**D212-664-241/-241B**  
**ASSEMBLY DETAIL**  $\triangle D$

DRAWING NO. D212-664-241	TITLE CROSSTUBE ASSY (205/212 HI AFT)	REV. D	DART AEROSPACE LTD ENGINEERING ORDER		D.E.O. NO. D212-664-241-D-1	SHEET NO. SHEET 1 OF 2	SCALE NTS
DRAWN	CHECKED	MFG. APPR.	APPROVED	DE APPR.			
DATE 11.04.07	DATE 11.04.11	DATE 11.04.12	DATE 11/04/12	DATE 11.04.12

ADD AN INSPECTION WINDOW TO UNDERSIDE OF CROSSTUBE.

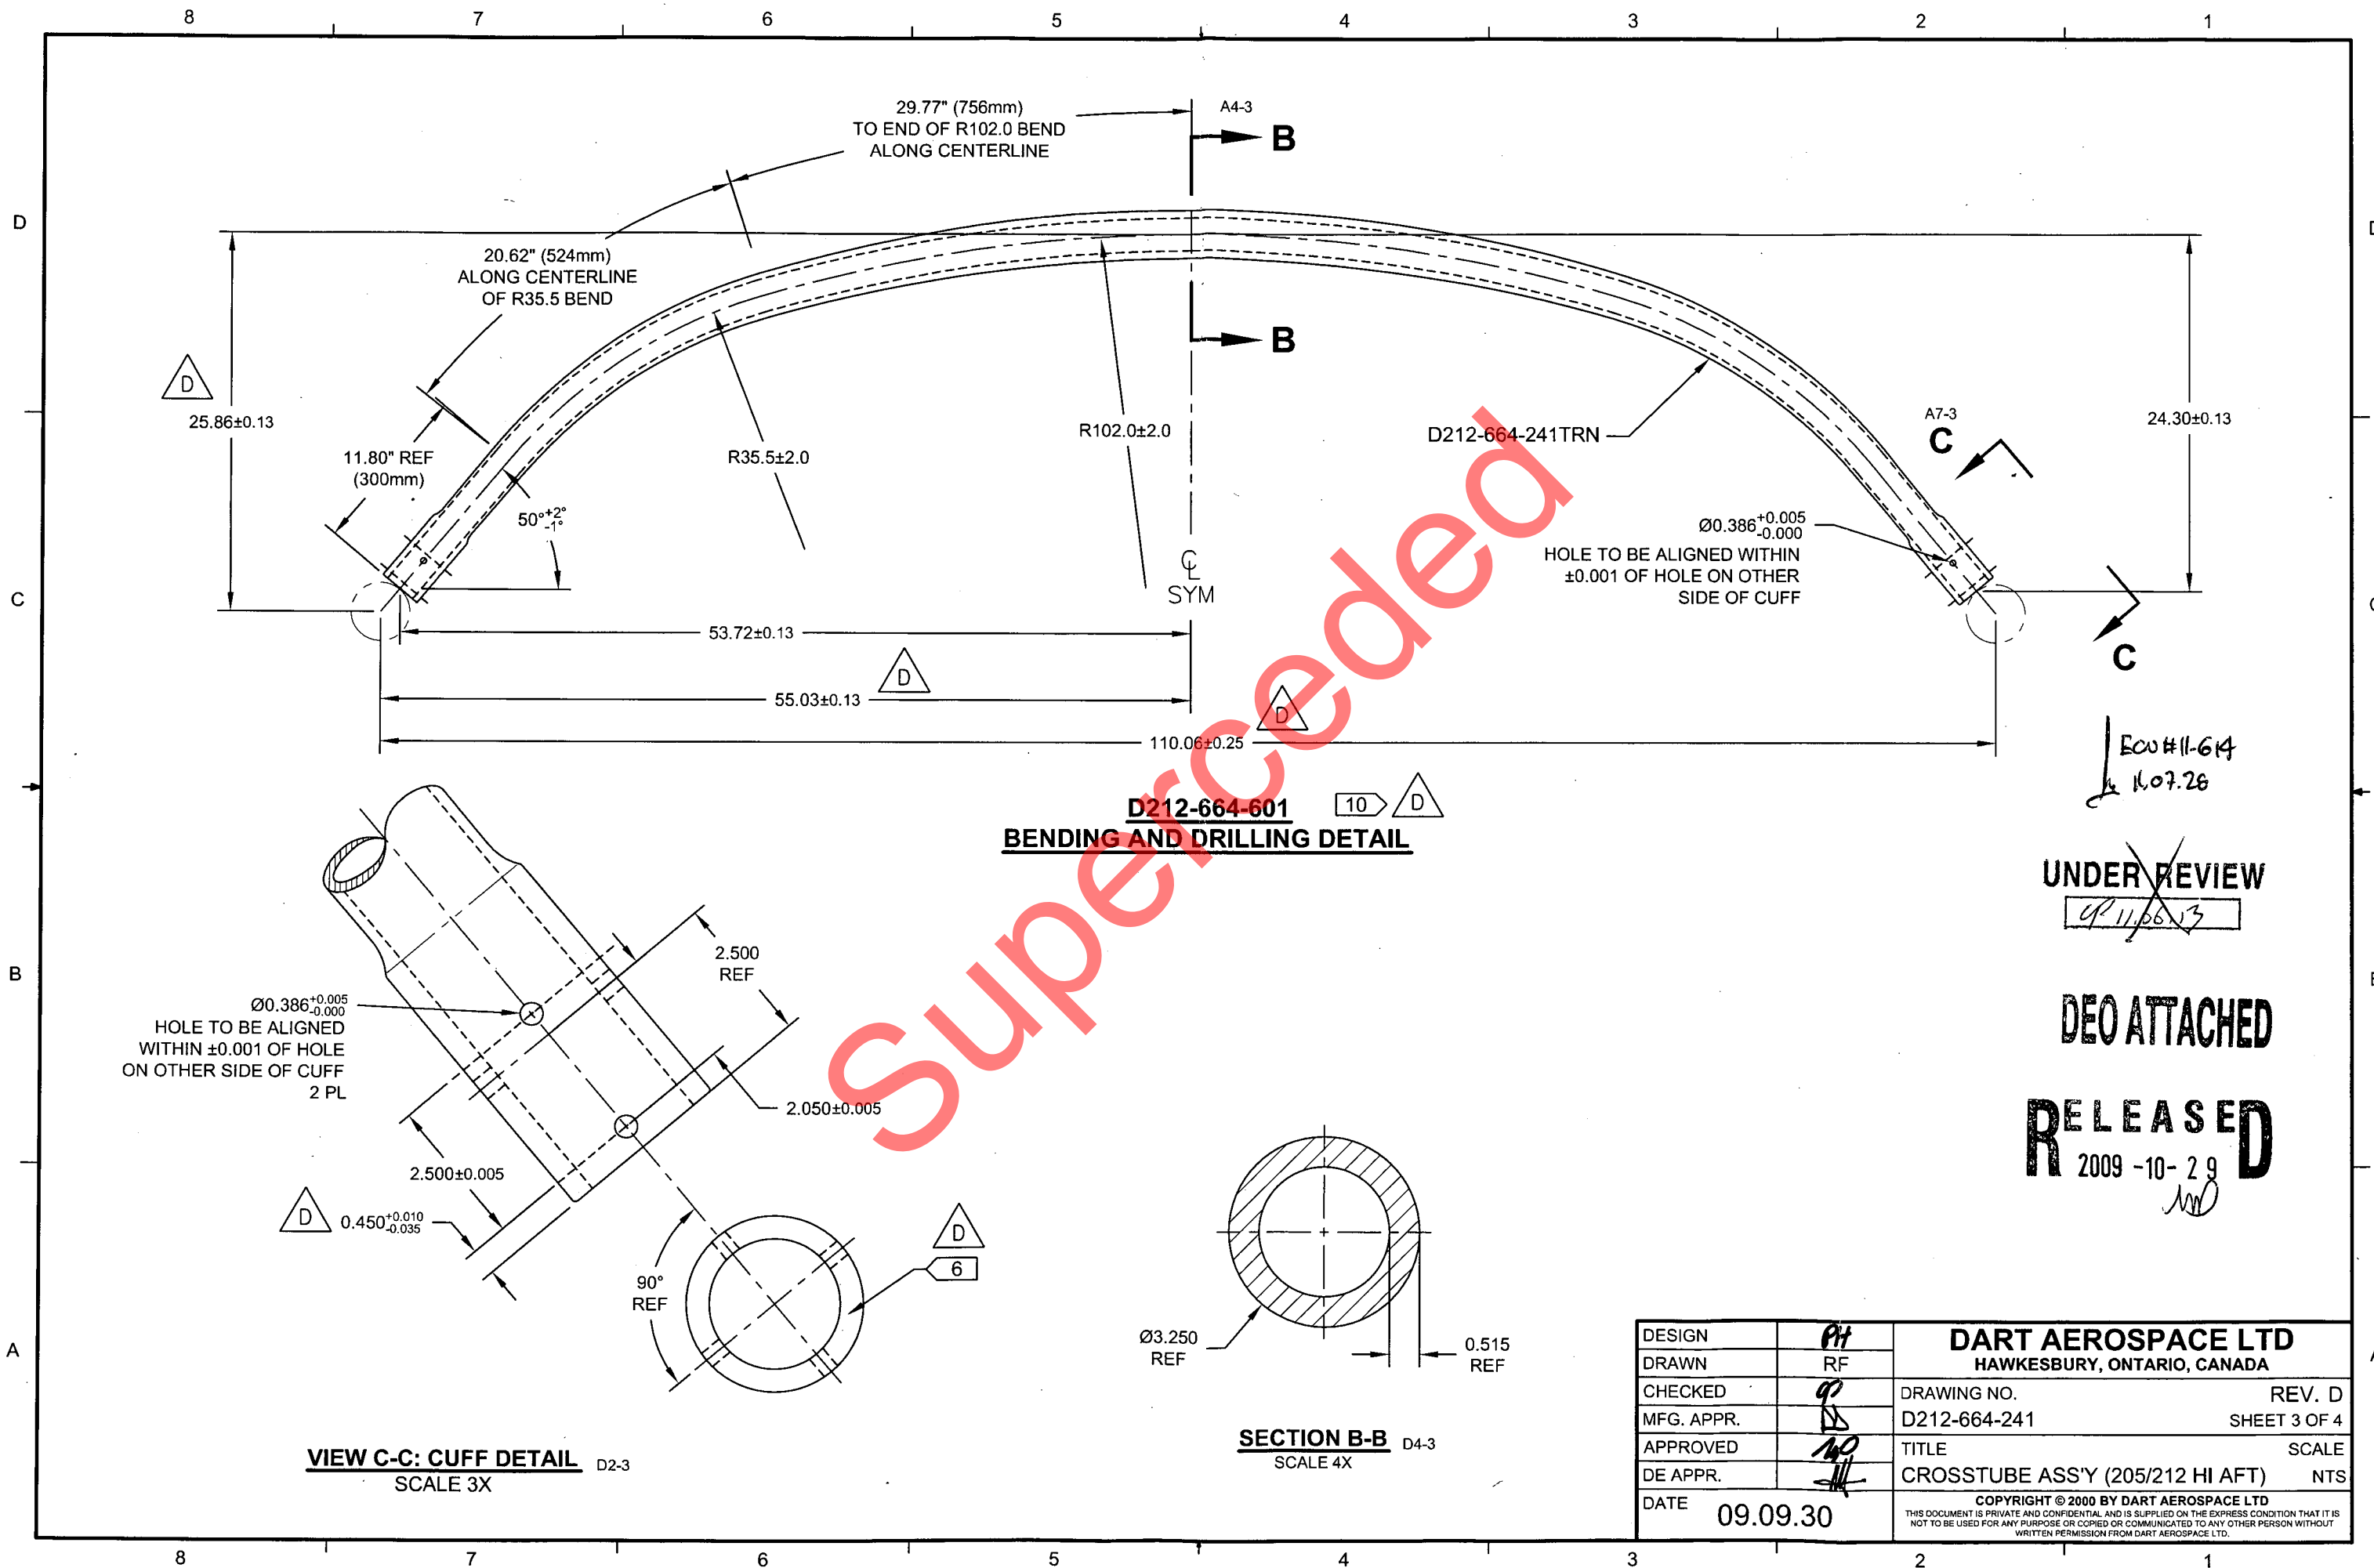
12  
APPLY MAGNOBOND  
BETWEEN D2940-1 AND  
CROSSTUBE

- 12) TO INSTALL D2940-1 SUPPORT: ABRASE MATING SURFACE OF SUPPORT AND CROSSTUBE WITH 180-GRIT SANDPAPER AND REMOVE RESIDUE WITH MEK (OR EQUIVALENT). APPLY A 0.04" TO 0.07" THICK LAYER OF PROSEAL 890 CLASS B-2 (OR AMS-S-8802 CLASS B-2) SEALANT TO MATING SURFACE OF SUPPORT.
- 15) TORQUE CLAMPS 80 TO 100 IN-LB. ENSURE AT LEAST 1.5 THREADS SHOWING IN SAFETY AND THAT NUT HAS NOT BOTTOMED-OUT AFTER TORQUING. PRIOR TO PACKAGING, RE-CHECK TORQUE ON CLAMPS AFTER PROSEAL 890 SEALANT HAS CURED FOR 72 HOURS.

**D212-664-241/-241B  
ASSEMBLY DETAIL**

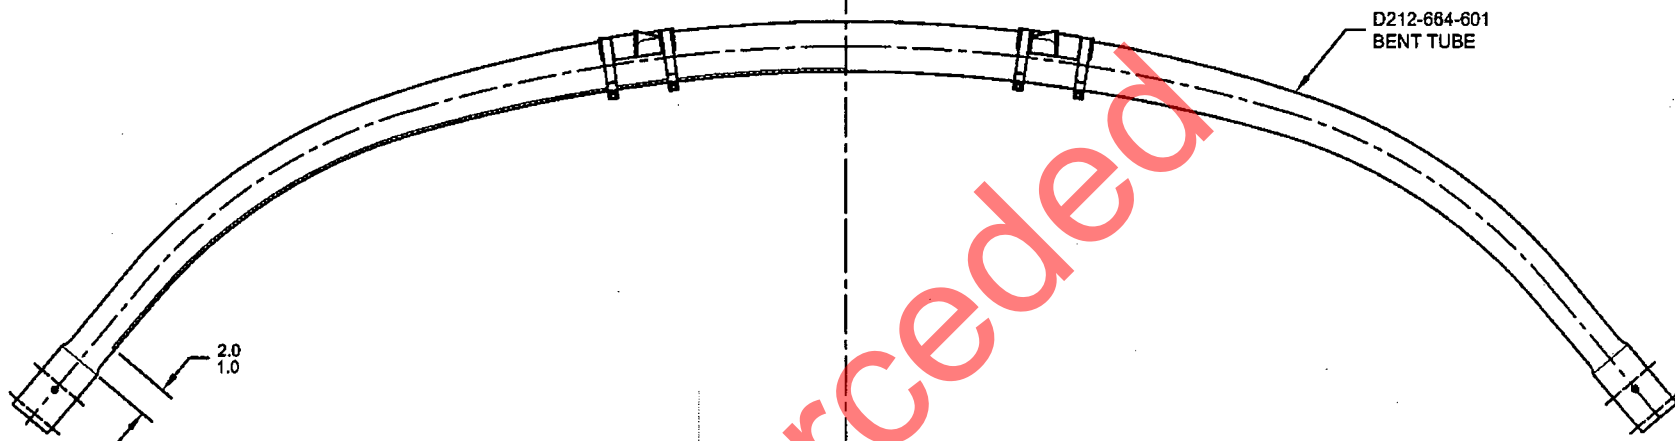
- 2) FINISH: CHEMICAL CONVERSION COAT PER DART QSI 005 4.1  
PRIME INSIDE AND OUTSIDE PER DART QSI 005 4.2  
MASK UNDERSIDE OF CROSSTUBE AS SHOWN (HATCHED AREA) AND  
PAINT OUTSIDE PER DART QSI 005 4.2  
REMOVE MASKING AND APPLY CLEAR COAT

MASK AREA PRIOR TO PAINTING,  
REMOVE MASKING AFTER PAINT  
AND APPLY CLEAR COAT
